Date: August 31, 2023 Our File: 1010-20-22-080
To: Mayor and Council
From: Hanna Demyk, Planning Technician
Copy: Jim Bailey, Director of Planning and Development Services
Michelle McGuire, Senior Manager of Current Planning and Urban Design
Re: **2237 Palmerston Avenue**

The purpose of this memo is to provide an update regarding improvements made by the applicant to the development proposal at 2237 Palmerston Avenue in response to comments provided at the July 17, 2023, Public Hearing.

Subject: 2237 Palmerston Ave – Subdivision

SITE PLAN
SCALE: 1/8" = 1'-0"

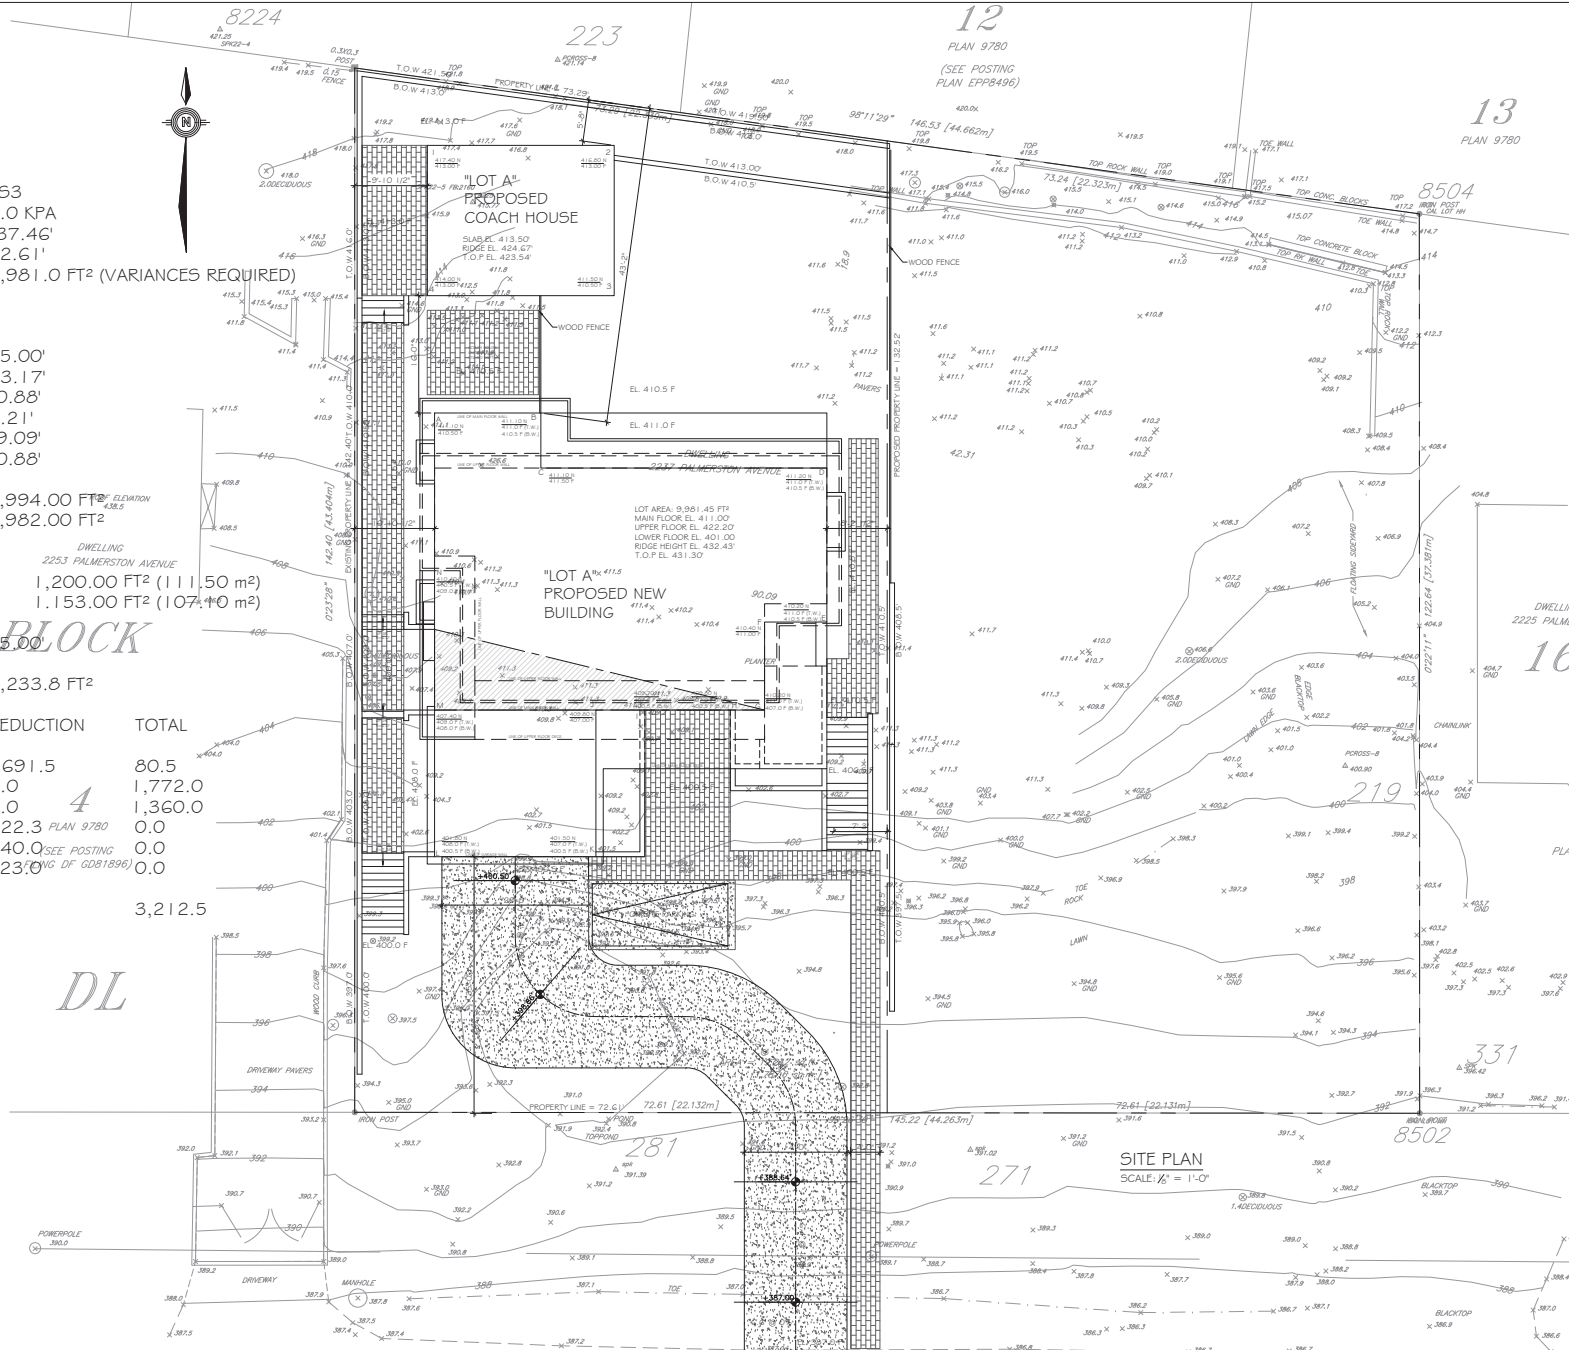
On-Site Parking for Coach Houses: In response to concerns about parking availability, we have located on-site parking for the coach houses within the property. This addition will significantly enhance the parking capacity and, reduce the potential parking-related issues that the public has concerns about. It is important to note that this addition exceeds the requirements set by the zoning bylaws, highlighting our commitment to addressing the community's concerns.

Protection of BLVD Hedges & Magnolia Tree: We asked our Arborist to have a second look at the project and to find a way that we can save as many hedges and trees as we can on the Blvd and on subject property. We are glad to say that we are able to save the beautiful Magnolia tree and have it as part of our proposed landscaping. The Magnolia tree will be protected by barriers during the construction of the new homes.
